SANITARY SEWER AS BUILT  
PAO #3

CEDAR PLAZA

SANITARY SEWER AS BUILT WATER AND SEWER 9/22/99

DRAWING NUMBER  
C-2A

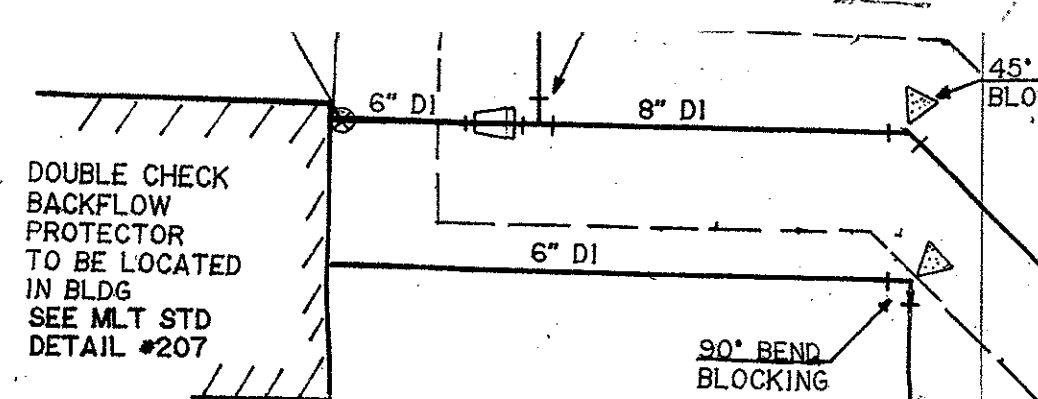
NOT  
VISIBLE  
DMS  
4/24/99

? APPROVED BY GREEN BEED?  
DMS 4/24/99
